Value Engineering Study

Final Report

VE Number: 202303

I-75 Widening, MP 20.2 to MP 28.851 Laurel & Whitley Counties

Phase 1

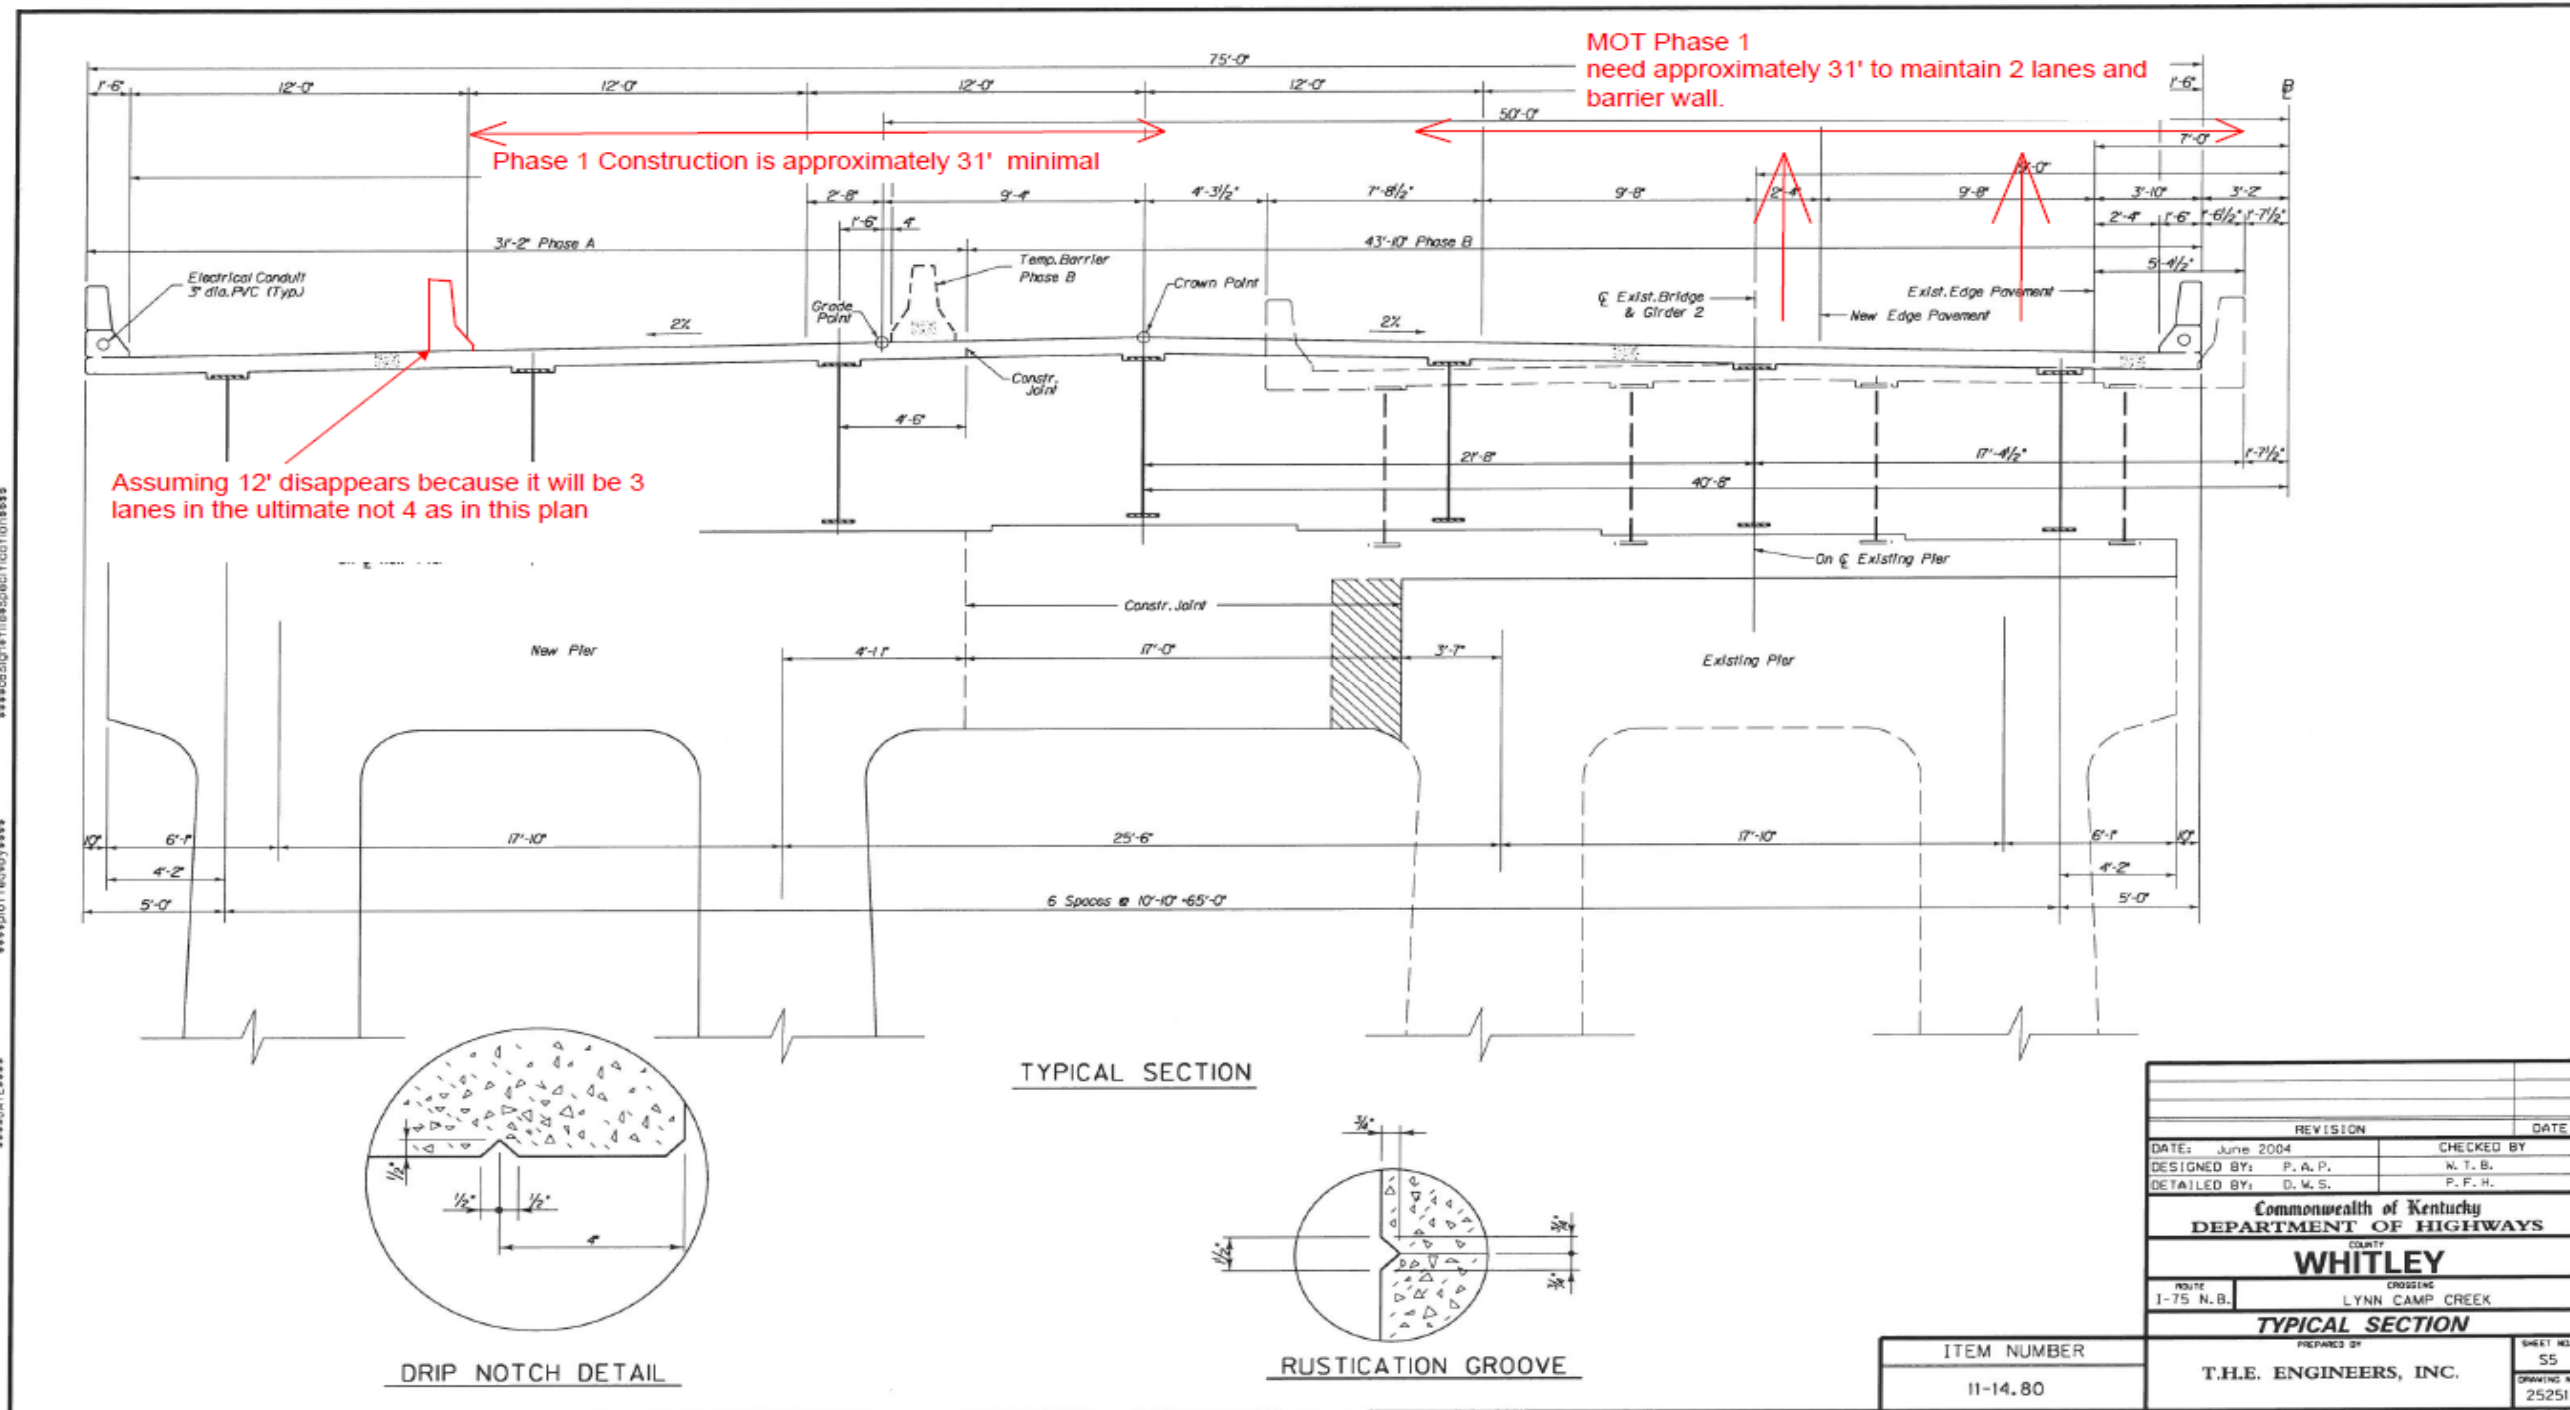
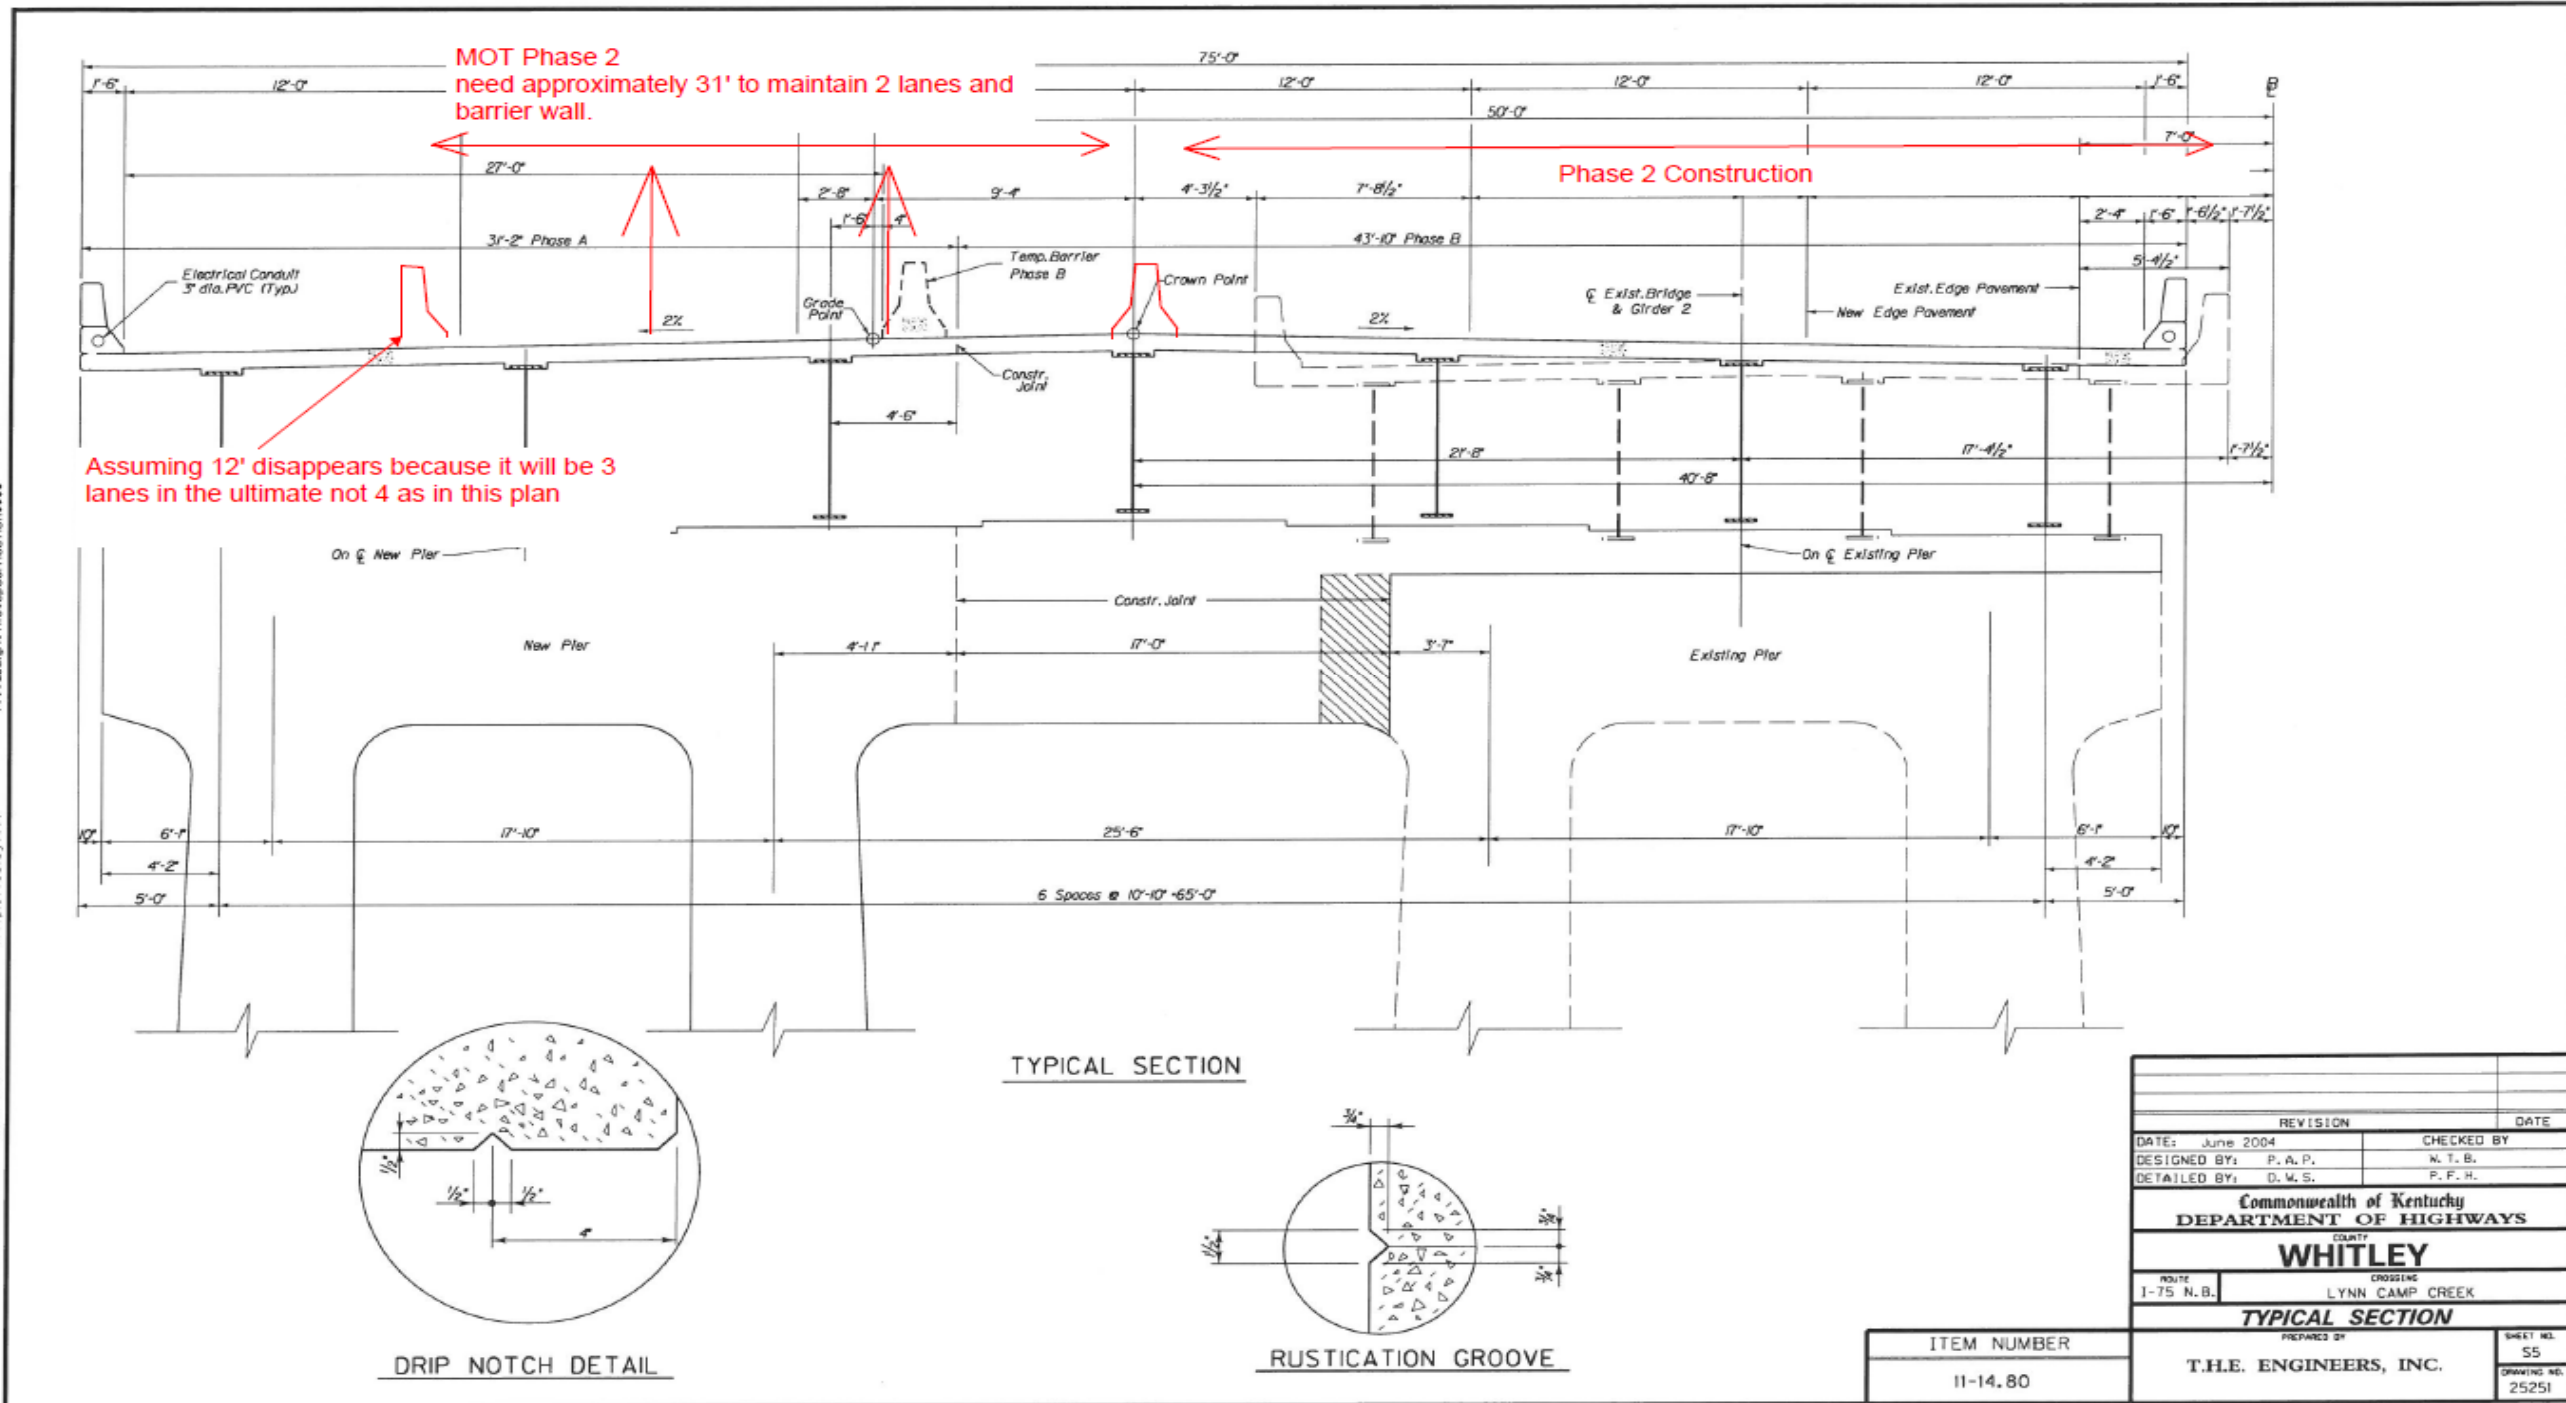
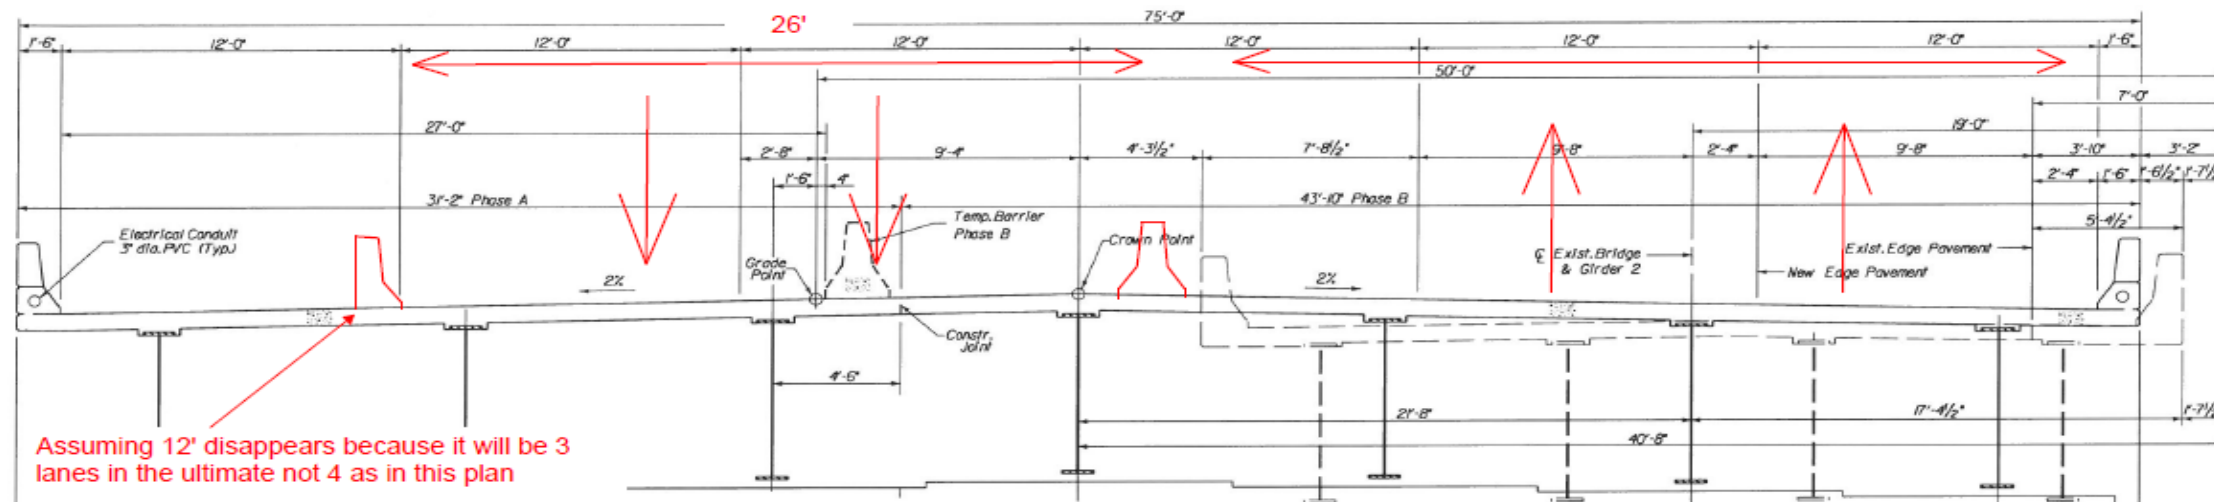
TITLE	Widen one structure on Lynn Camp Creek Bridge to provide 4 lanes of traffic (2 in each direction) in order to minimize construction phasing on the second structure
--------------	---

TITLE	Widen one structure on Lynn Camp Creek Bridge to provide 4 lanes of traffic (2 in each direction) in order to minimize construction phasing on the second structure
DISCUSSION & JUSTIFICATION:	
<p>Construction of the piers for the widening will take a considerable amount of time each. With the contractor forming and pouring about 20' at a time, we are estimating approximately 6 months each side for the substructure. By building one direction in 2 phases, we allow for complete demolition of the other bridge. The limiting factor for a vertical pour is the height. The contractor would be able to form and pour all the substructure for each lift as opposed to splitting it up. This could in turn lead to a different pier design on the second structure since the existing bridge will be completely removed first.</p> <p>By building the structure as one unit instead of phasing, you can eliminate the longitudinal construction joint in the pier, the longitudinal construction joint in the deck, the phased placement of armored edges and joint material. All this can be done while not impacting the traveling public at all. 2 lanes can be maintained on the new structure built in phase 1 and 2.</p> <p>The contractor will be able to stage material for the second bridge in the closed portion of interstate, receive beams safer, minimize any crane pads needed below (would only need one pad per pier instead of two). There is little doubt that the Lynn Camp Creek bridge will be the critical path for the project. By eliminating the 2 phase from the second bridge we immediately save 6 months off the construction.</p> <p>While crossovers do cost money, the logical locations for cross overs can exist in the areas just north and south of the bifurcated areas, allowing the majority of temporary pavement needed to actually line up with permanent pavement.</p> <p>The cost to construct these cross overs is minimal when compared with time savings and joint elimination which is one of the main locations where we see bridges begin to deteriorate.</p> <p>The cost estimate reflects a price change in concrete class A and concrete class AA. While the typical section of the bridge doesn't change, by reducing the phasing the contractor no longer needs the pump truck for those two phases. They also no longer need the bidwell and deck pour crew for two phases, just one. The production rate of the crew can increase because the contractor can form twice as much as they normally would during phased construction (due to vertical limitations).</p> <p>The median cross over is assuming leveling and wedge at 3" average depths to obtain super elevations. Assuming a 50 median width, and a length of 2000' at 26' width, that equates to \$88,000 per crossover.</p>

Assuming 12' disappears because it will be 3 lanes in the ultimate not 4 as in this plan

MOT Phase 3
58' out to out to maintain 2 lanes in each direction and 2' shoulders across the bridge, 2.25 for temp barrier and 1.5' for perm outside barrier. Assuming new bridge will be 63' out to out.
